TVA-WBN-TS-08-04

**WATTS BAR NUCLEAR PLANT (WBN) UNIT 1 - RESPONSE TO REQUEST FOR  
ADDITIONAL INFORMATION RE: WATTS BAR EMERGENCY CORE COOLING SYSTEM  
BORON REQUIREMENTS (TAC NO. MD9396)**

**Response to NRC Request for Additional Information (Non-Proprietary)**

**Figure 1 - Boric Acid Solubility Limit**

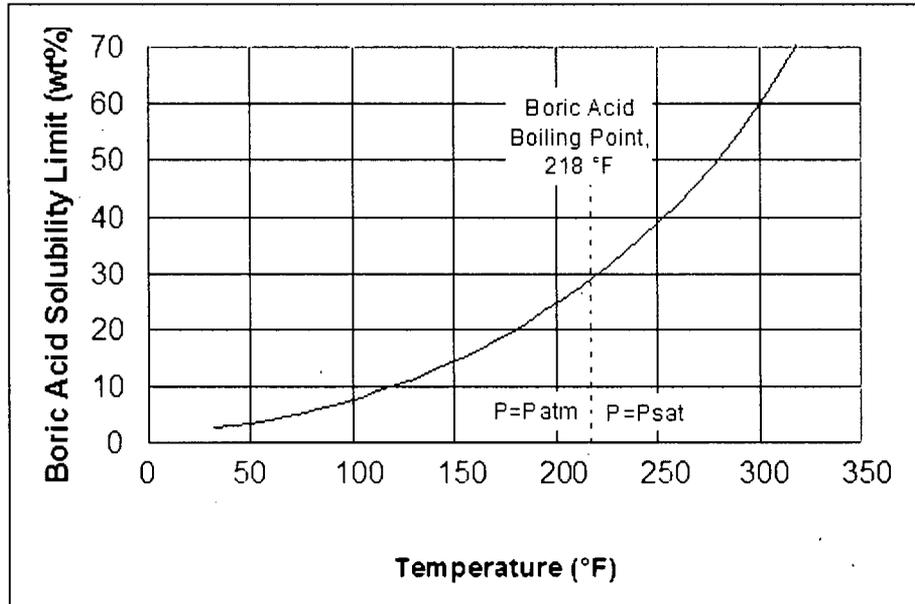
The NRC staff is aware that a boric acid concentration calculation has been performed that more closely aligns to the NRC staff's current expectations and acceptance criteria regarding the precipitability of boric acid in the long-term phase following a LOCA. Please provide a summary of this calculation.

- *The boric acid concentration limit is the experimentally determined boric acid solubility limit as reported in Reference 2 and summarized in Table 2 and Figure 1. For large breaks and large small breaks, the effect of containment or RCS pressure above atmospheric pressure is not credited and the boric acid solubility limit at 212°F is assumed. For large small breaks where RCS depressurization is not complete or for even smaller small breaks where the RCS might be at elevated pressures at hot leg switchover time, the solubility limit associated with the saturation temperature of water at the associated elevated pressure is credited.*
